Water Budget Evaluation for a Proposed Reservation for Lake Hancock and Lower Saddle Creek in Polk County, Florida

Draft

Attachment B. District Staff Response to an Initial Peer Review of “Proposed Reservation for Lake Hancock and Lower Saddle Creek in Polk County, Florida” (Report) (includes December 5, 2019, Peer review report tables with District comments)

Figure 13. Flow difference between Fort Meade and Bartow versus flow less than 30-cfs at Fort Meade for the 1975 through 2012 period used for this study; note negative differences are not shown

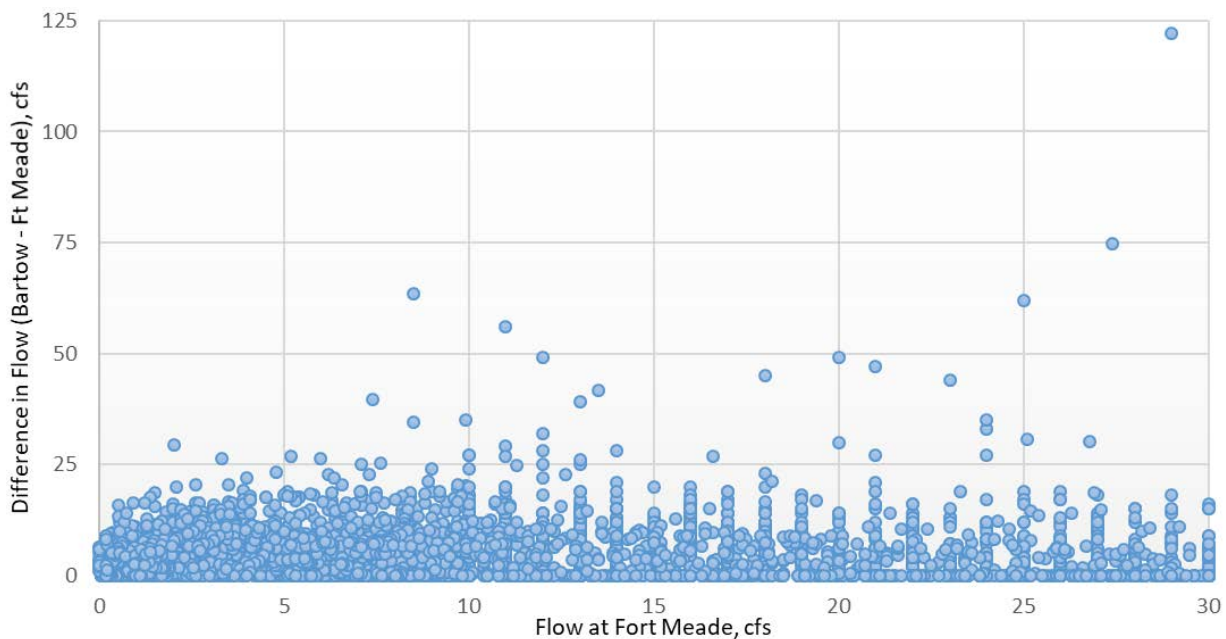
A. Reviewer's Specific Comments	B. District Response
11	Fig. 10	No	It appears that flows above 10 cfs at Fort Meade were reported to the nearest cfs. Also Figure title is on the next page	The data used for the plot were downloaded from USGS. District staff noticed the format of the data is not consistent over the period of analysis (e.g., one decimal place is shown for data values less than 100 cfs but greater than 1 cfs for the period since water year 2002). The District used the original downloaded data and no alterations were made. The x and y axes labels used for the report figure were formatted to include no decimal places.
12	Pg. 21	Potentially	The mathematical discussion of how adjustments were made to downstream flows should be elaborated on for understanding or clarity. May have to adjust outfall discharge estimates based on what happened historically at USGS gauge at Bartow. Basically, whatever adjustments were made at Bartow because of changes in P-11 discharges should be reflected similarly at the other downstream gauges.	To better present model development, model setup and adjustments, Section 2.3 was restructured, and additional text was added per both reviewers' comments. We note that the adjustment in P-11 flow is reflected in flows for all downstream gages. However, sites downstream of Bartow have additional impacts due to sink loss.

Figure 1. P11Q residual histogram (Historical vs Baseline scenarios)

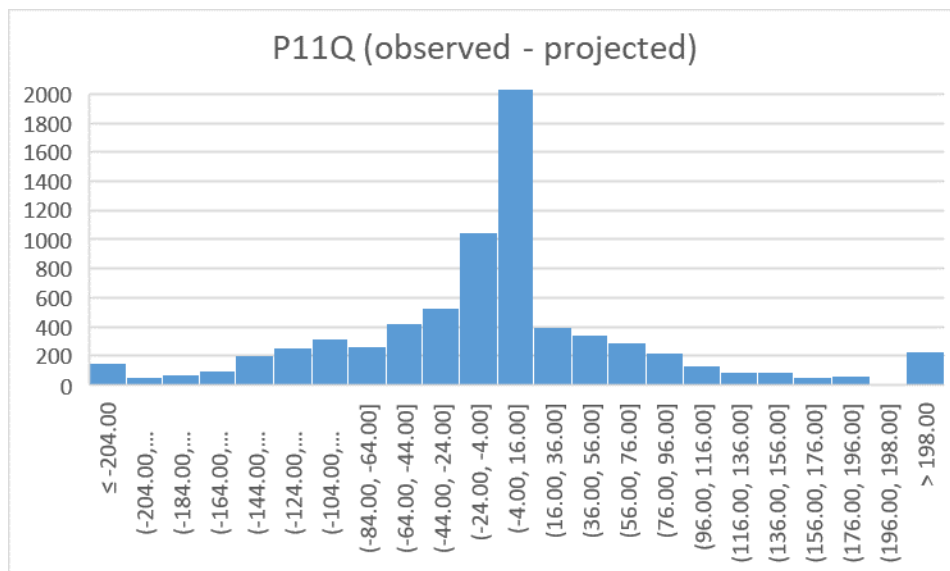
As an example, the piecewise linear functions (Figure 8 page 17) effectively represent the application of the P11 Structure operating rule in the water budget model scenarios for both the baseline (former structure) and current scenarios. Upon inspection of the water budget model Excel file, the residuals (observed – projected) were found to sum to near zero (accounting for wastewater deduction) and appear to be symmetrically distributed (Figure 1) supporting the use of the regression model. Other figures are provided for consideration in the attached comments.

Figure 3 A, B, C. Flow duration curves for P-11 operating scenarios at different scales

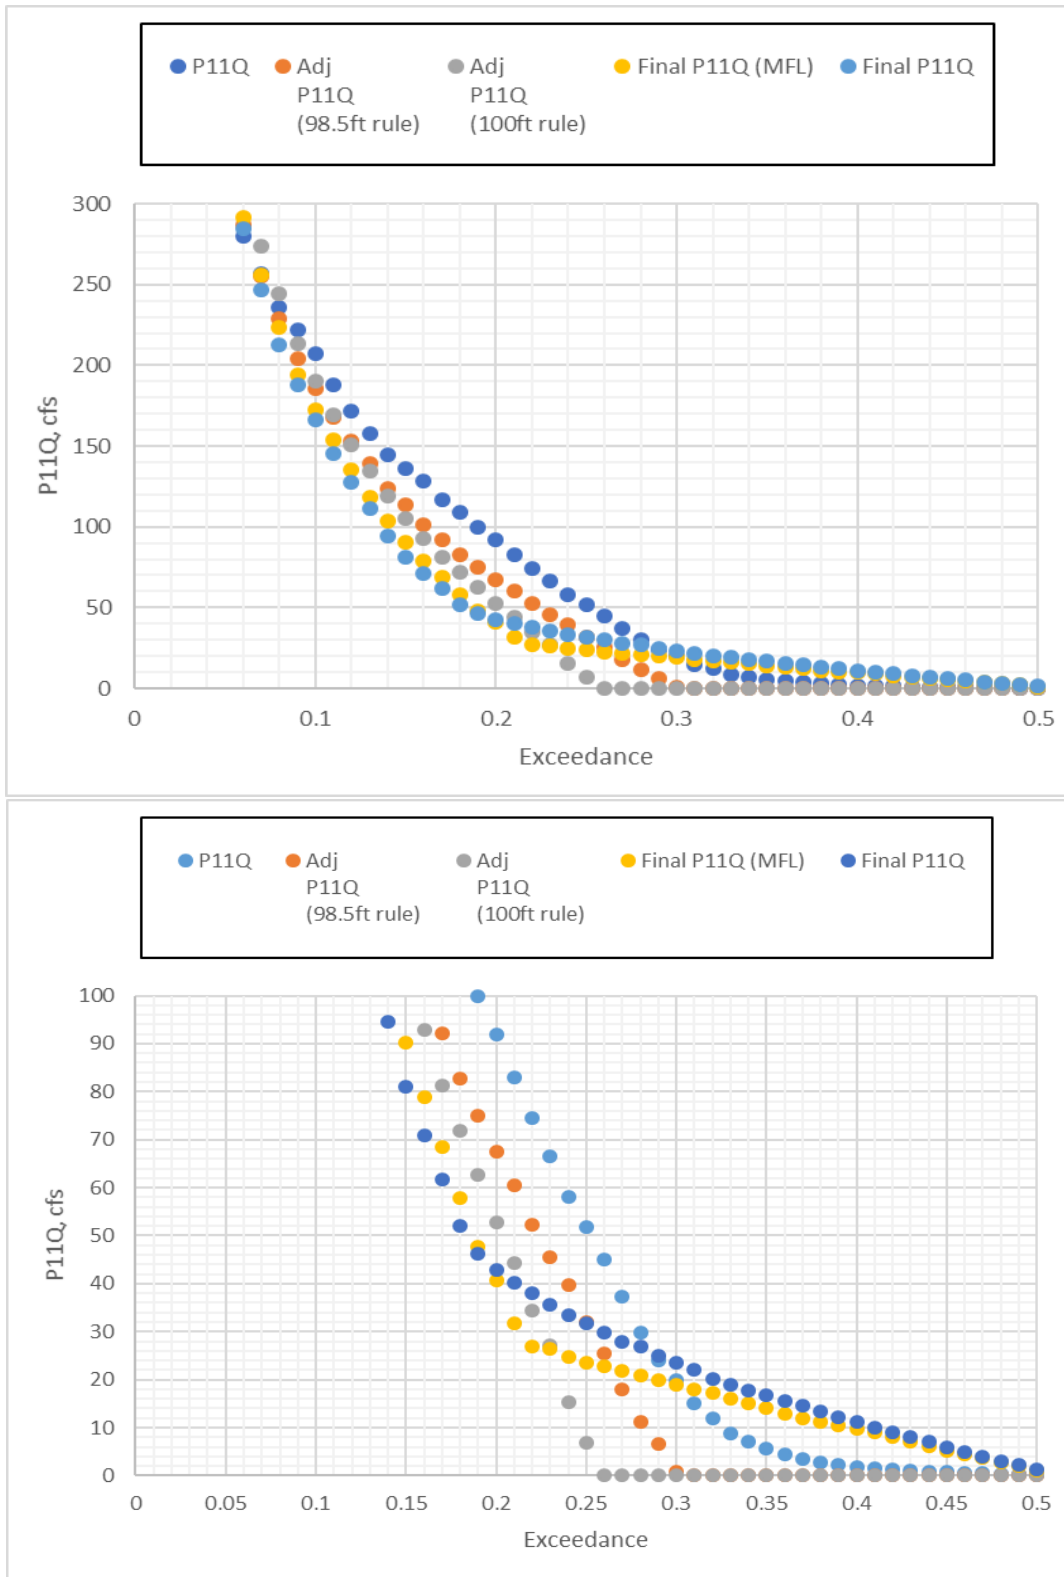
Several duration curves were provided in the comments (Table 1) which may help with displaying the impacts differently than the bar charts presented in the report. For example, Figure 3 (in Attachment A of Table 1) is a lake stage duration curve (SDC) under the various model scenarios along with regulatory levels. Figure 2 (Attachment A of Table 1) depicts flow duration curves (FDC) for the various scenarios and identifies clearly where the MFL augmentation flows are coming from on the FDC, for example.
